POLICY REPORT
DEVELOPMENT AND BUILDING

Report Date: November 30, 2010
Contact: Kent Munro
Contact No.: 604.873.7135
RTS No.: 08972
VanRIMS No.: 08-2000-20
Meeting Date: December 14, 2010

TO: Vancouver City Council
FROM: Director of Planning
SUBJECT: CD-1 Rezoning at 3522 Porter Street

Diagram 1.

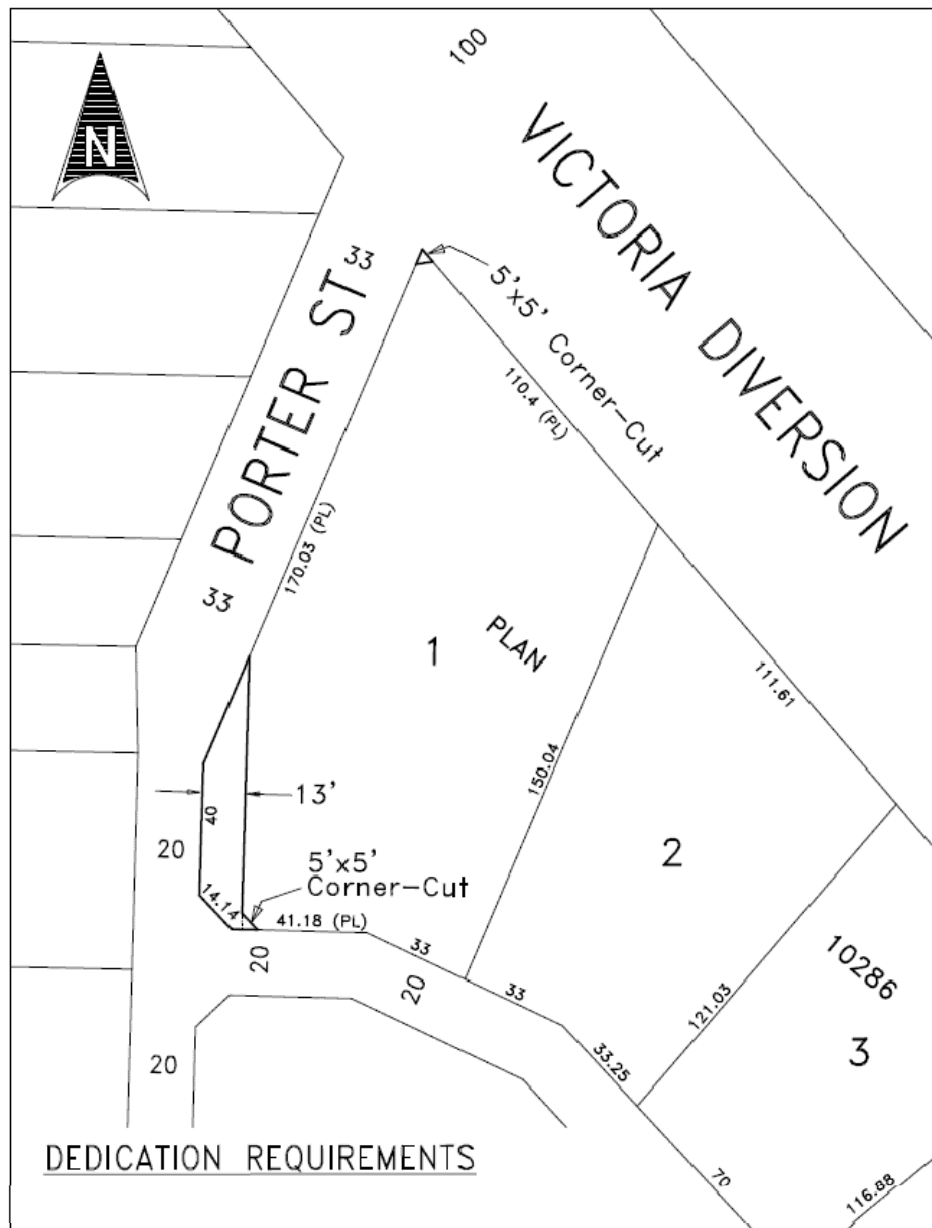
- b. Dedication of a 5x5 ft. corner cut at the north west corner of the site, as shown in Diagram 1 on page 8 of this appendix, to provide adequate pedestrian space and circulation at this corner;
